Re: **Arizona Department of Environmental Quality ADEQ Clean Water Action Section
401 certification for Rosemont Copper, Public Notice 27-14AZ LTF 55425**

This letter presents the combined comments of the Pima County Regional Flood Control District (RFCD) and Pima County regarding the proposed 401 certification for the Section 404 permit for the Rosemont Copper Project, Public Notice/Application No.: SPL-2008-00816-MB. The corresponding address is provided above.

This letter presents additional consolidated comments by the Pima County Regional Flood Control District and Pima County on the Draft 401 certification for the Clean Water Act Section 404 permit for the Rosemont Copper Project. After I sent our comments to you, the Arizona Department of Environmental Quality (ADEQ) extended the comment period until April 7, 2014. ADEQ has also provided a copy of the agency's basis for the proposed certification that was not available during our previous review. Thank you for making this document available.

FIGURE 8. GRAPH OF DEUTERIUM VERSUS DELTA OXYGEN-18 FROM WELLS, SPRINGS, AND SURFACE WATER LOCATIONS, APRIL THROUGH OCTOBER 2008, ROSEMONT AREA

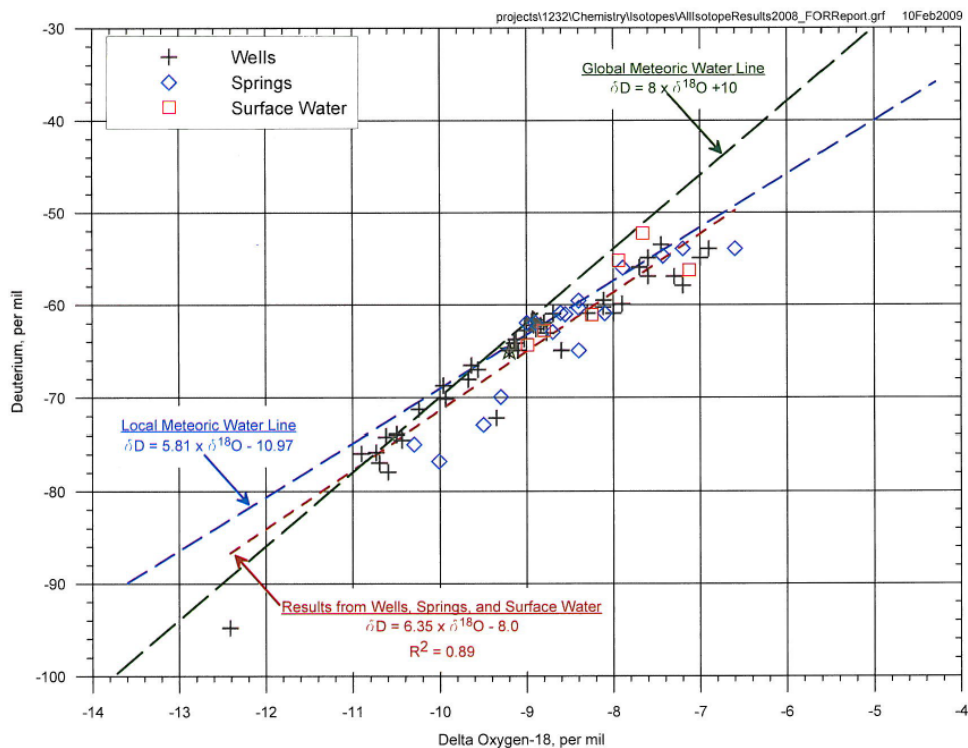
This is also shown graphically on Figure 8, Graph of Deuterium Versus Delta Oxygen-18 from Wells, Springs, and Surface Water Locations, April through October 2008, Rosemont Area (Montgomery and Associates, 2009). This figure is reproduced below. Wells are crosses. Note that the well delta oxygen values range from -12 to -7 on the horizontal scale. Note also that range of values for springs (diamonds) occupies nearly the same range, excepting the singular well value at RP-4B, which is a deep well screened in the Apache Canyon Formation.

4. Referencing Montgomery's Figure 8 again, note that all of the samples, even the PC wells, plotted below the Global Meteoric Water Line. This is not disclosed by Tetra Tech, and in fact the Tetra Tech plot actually obscures this fact by plotting a dashed line that does not represent the Global Meteoric Water Line. It can be seen that the intercept of Tetra Tech's line is much lower than the Global Meteoric Water Line that Montgomery shows. The slope of the local data, and the values of the PC wells considered as a group *both show substantial influence from natural evaporation during precipitation, runoff and / or recharge*, as was noted by Montgomery and Associates in their 2009 report. Tetra Tech did not discuss Montgomery's observation of an evaporative effect, presumably because it did not fit their preferred interpretation.

6. Figure 8 (Montgomery and Associates 2009) also has a local meteoric water line (LMWL) derived from data provided by Dr. Chris Eastoe. In attachment 3, Dr. Eastoe presents a more robust dataset for a LMWL. LMWL's are important because they provide a basis for interpreting sample results.

Tetra Tech Figure 17

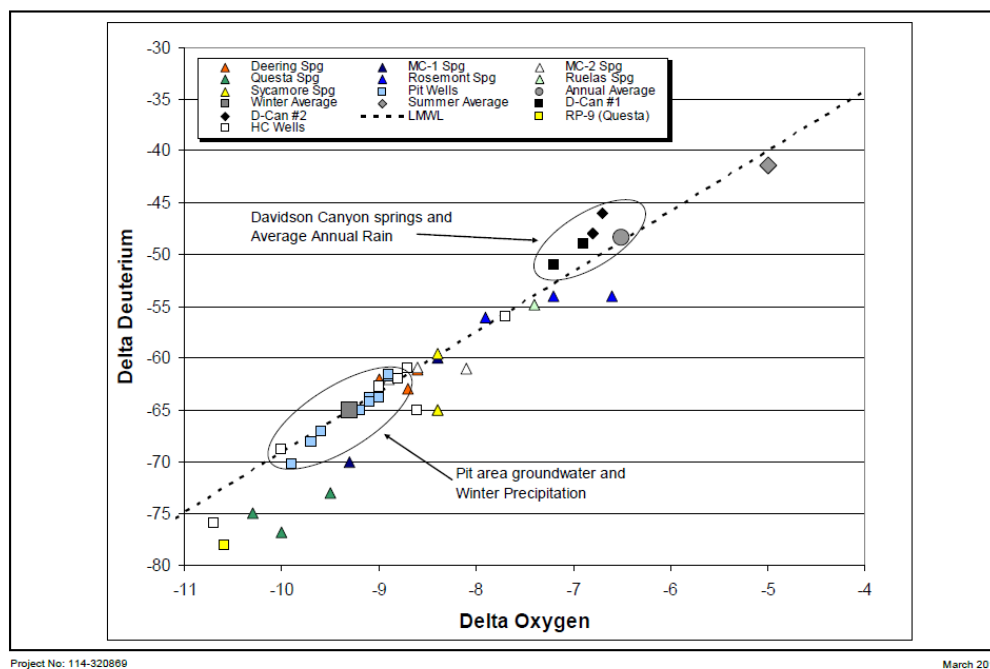
Some of these same data are shown on Figure 17 from Tetra Tech (2010), which differentiates the pit area groundwater (primarily PC well series) from other wells and springs in the mine vicinity. While it is true that the pit well data are largely grouped in the lighter oxygen values, many of Montgomery's other well and surface water data plot right along the red line calculated by Montgomery using the entire data set, suggesting that they are from the same population.

5. Tetra Tech's Figure 17 includes a data point representing winter average rainfall. This value is important because it is the principal basis for the inference that the position of the "*pit area groundwater*" on figure 17 means that *winter precipitation* is the source of the groundwater for the PC wells. Tetra Tech says that the winter average value is based on "stable isotope data for local precipitation" by Wagner (2006). Page 124 of Wagner 2006 provided several years of precipitation data from the vicinity of Cave of the Bells, in the Santa Rita mountains farther south. There were too few years in Wagner's sample to define a local meteoric water line (Dr. Chris Eastoe, personal communication).

10. Tetra Tech omitted well data that did not support their hypothesis. Tetra Tech's Figure 17 omits many of the wells and spring samples that plotted closer to the PAG dataset, but retained the "pit wells" that favored Tetra Tech's interpretation. The omitted samples that plotted closer to the PAG data set included wells RP-4A and RP-3A located in areas under the waste rock and tailings landform, and Rosemont spring, which would also be covered with waste rock and tailings.

FIGURE 8. GRAPH OF DEUTERIUM VERSUS DELTA OXYGEN-18 FROM WELLS, SPRINGS, AND SURFACE WATER LOCATIONS, APRIL THROUGH OCTOBER 2008, ROSEMONT AREA

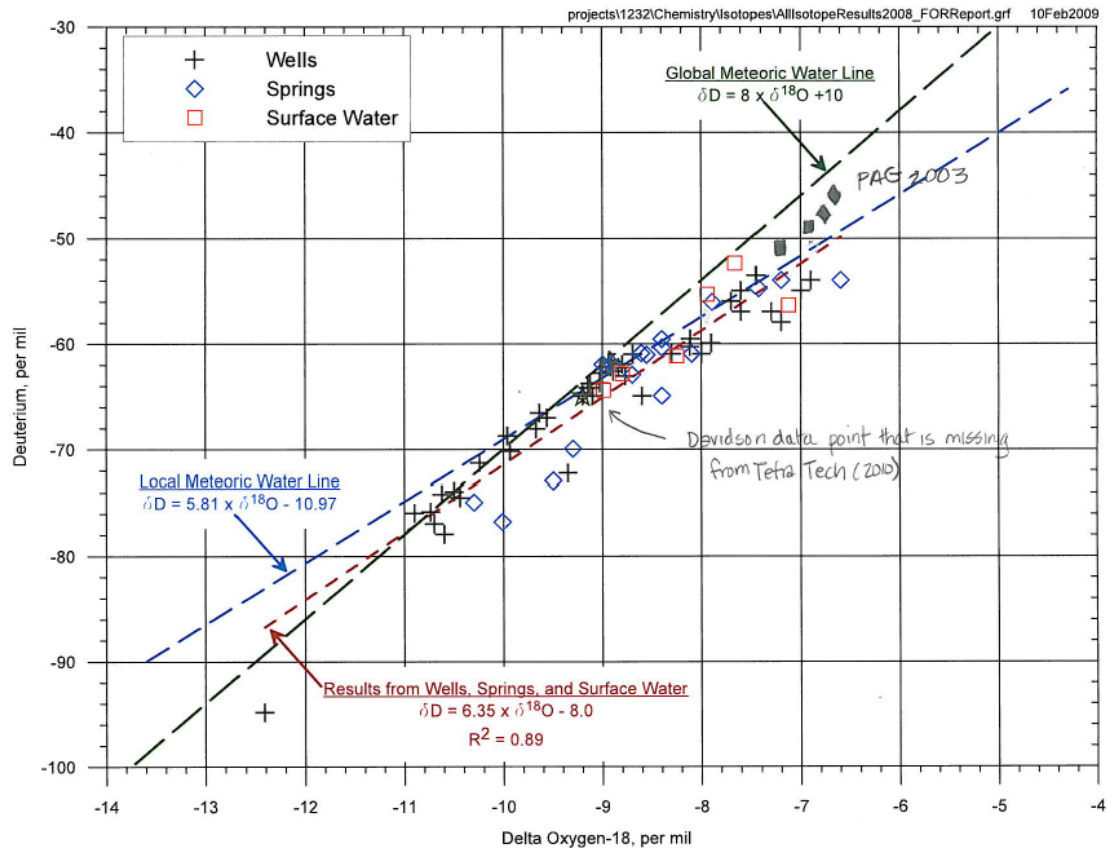
12. Turning now to the Davidson surface flows, Tetra Tech fails to plot or discuss the sample results shown on Montgomery's Table 12 for lower Davidson Canyon Wash. **This sample has a $\delta^{18}\text{O}$ value equal to -9.** This is similar to the pit wells and the so-called winter precipitation. Thus, Tetra Tech's interpretation regarding the character of Davidson spring **is not supported by the only sample which was contemporaneous with the well data to which it is compared.** No explanation is offered in the Tetra Tech report for this omission.

13. While ignoring contemporaneous Montgomery data that does not support their hypothesis, Tetra Tech included PAG 2003 data for Davidson. Below I have plotted the PAG data by hand on Montgomery's graph above for convenience. The line defined PAG's 2003 Davidson samples plots is within the trend line defined by Rosemont area groundwater. It does not plot below the trend line, with a flatter slope, which is what you would expect if the Davidson discharges were "local springs".

Figure 5
Pima County Well Hydrograph

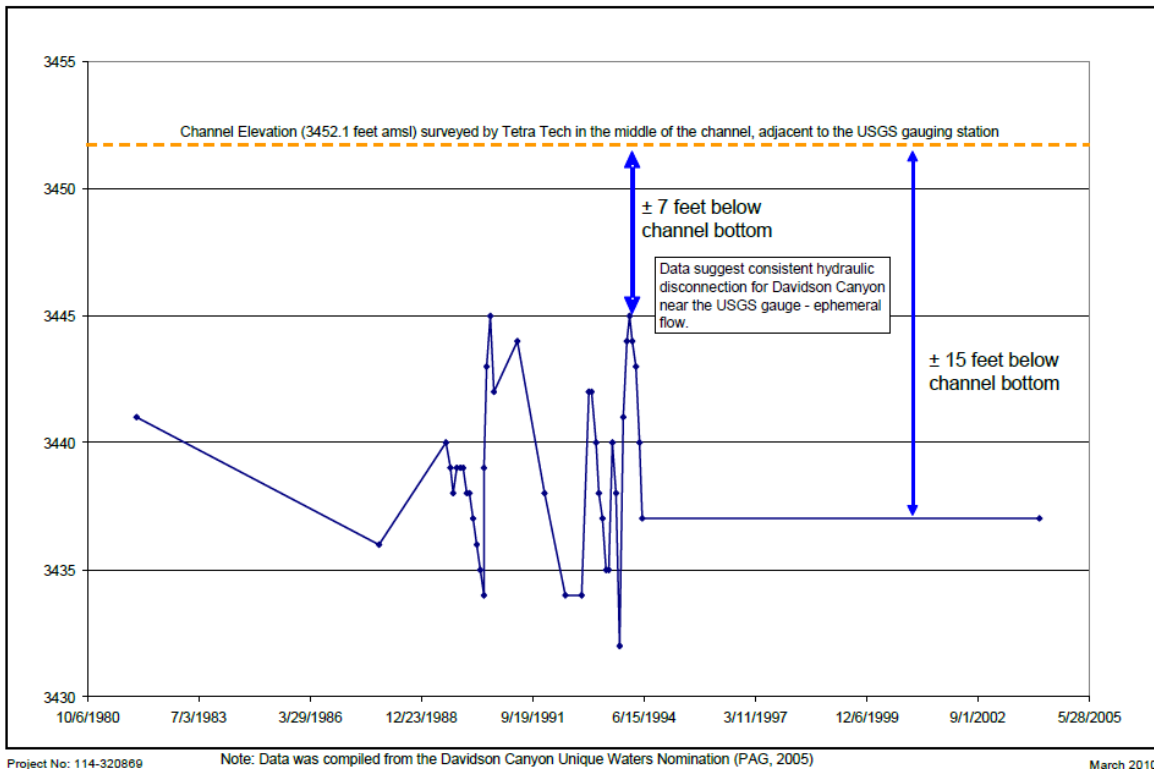
Tetra Tech misrepresents the PAG (2005) data by plotting a line connecting individual observations separated by years. Tetra Tech further misrepresents the data by adding a text box on the graph interpreting the time between 1994 and 2005 as data suggesting a hydraulic disconnection, when it actually represents a data gap in the cited report (PAG 2005).

During the data gap shown on Figure 5 (1994-2005), Pima County obtained observations of flow and absence of flow from Sky Island Alliance. The observations were made at locations of animals tracks observed in the Davidson Canyon stream bed from the Interstate 10 bridge to 1.5 miles south. This reach includes Davidson adjacent to the County well mentioned above. During 2002-2005, there was either damp soil, running water, or standing water on 12 of 26 (46%) of the Sky Island sampling occasions. These observations were made during the 2002-2006 drought.
